# Revision updates for WES-2023-33

## Note to the editor

## 2. Comments and updates for referee 1: David Schultz

Figure 1: Histograms of the instantaneous temperature gradient between 90 m MSL and 21 m MSL based on 10-minute data for the period 2012-2015 at the location of measurement mast Ijmuiden (MMIJ). Lightgreen: only COSMO-CLM; Grey: only the measurements; Green: overlap between the histograms.

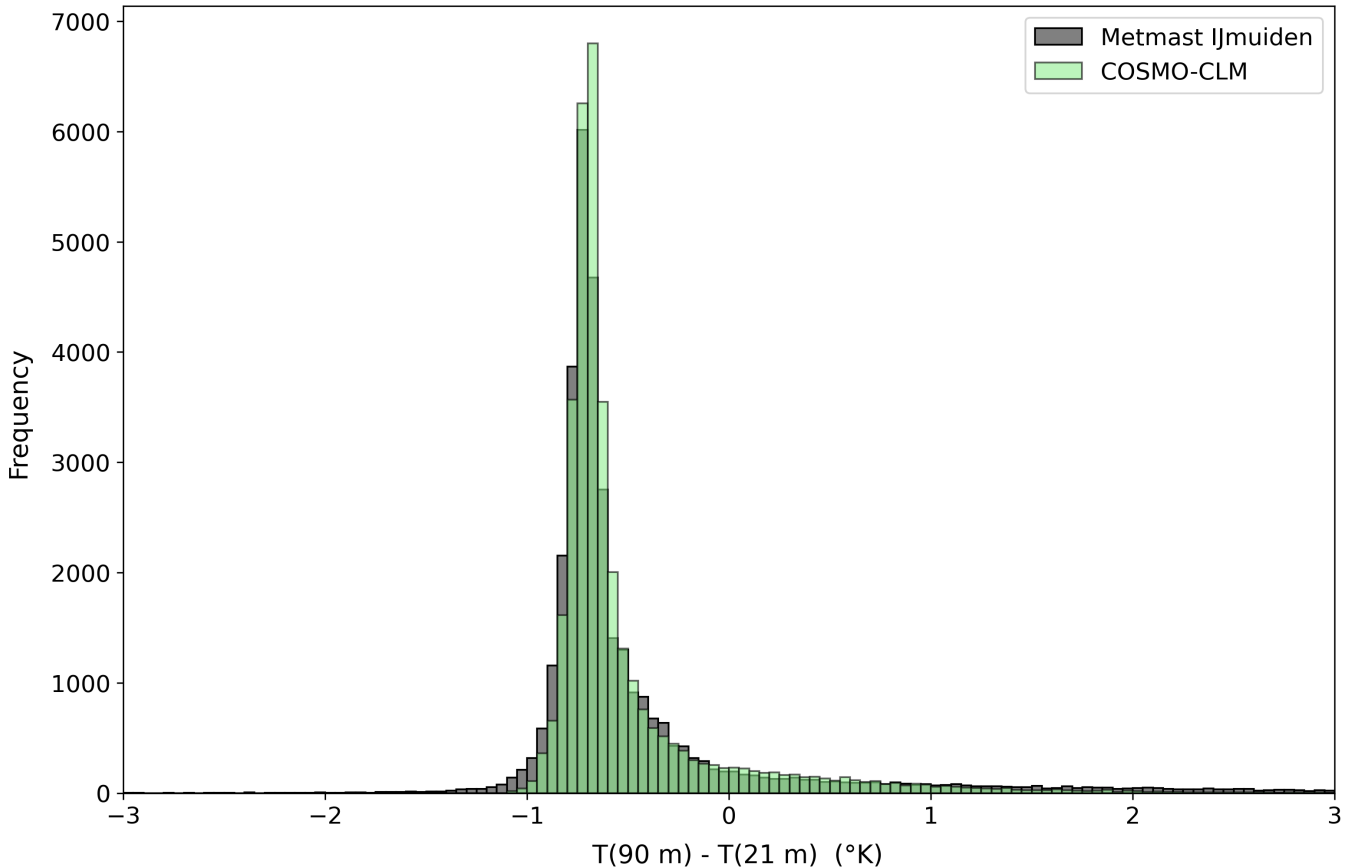
**Comment 1:** It will be nice to get an indication of the accuracy of the simulated model stability classes. Since you are using these frequencies to split the wake losses among stability classes, it would be good to know if they relate to reality. We know the SSTs are input to the model simulation, so could we verify the temperature above the sea using buoy data? For the NEWA project, we estimated that the stability classes could be different by as much as 10% when a different PBL was used in the simulations (see Figures 11-13 in NEWA D4.3 report).

**Update:** As we proposed in the reply, we have handled this concern by performing a temperature gradient validation at Meteomast Ijmuiden. We believe that a validation over the available height range (21m-90m) is more suitable than close to the surface, because it is closer to the height range over which our stability criterion is evaluated. This validation was done for a 4-year period (2012–2015). An additional supplementary figure (supplementary Fig. S5) has now been added which shows the long-term histograms of the temperature gradient for the measurements at the station and the corresponding model data. Although the match is not perfect, the agreement is good (along with a negligible difference in the mean) which supports the validity of doing the stability subdivision with the Bulk Richardson criterion as we did it. At line 257 in the old manuscript the following text has been added to discuss this comparison:

*A comparison of the modelled temperature gradients with measured temperature gradients at the station MMIJ between 90 m MSL and 21 m MSL shows a good correspondence in the long-term temperature gradient probability distribution, indicating sufficient model skill for this subdivision into stability classes (supplementary Fig. S5).*
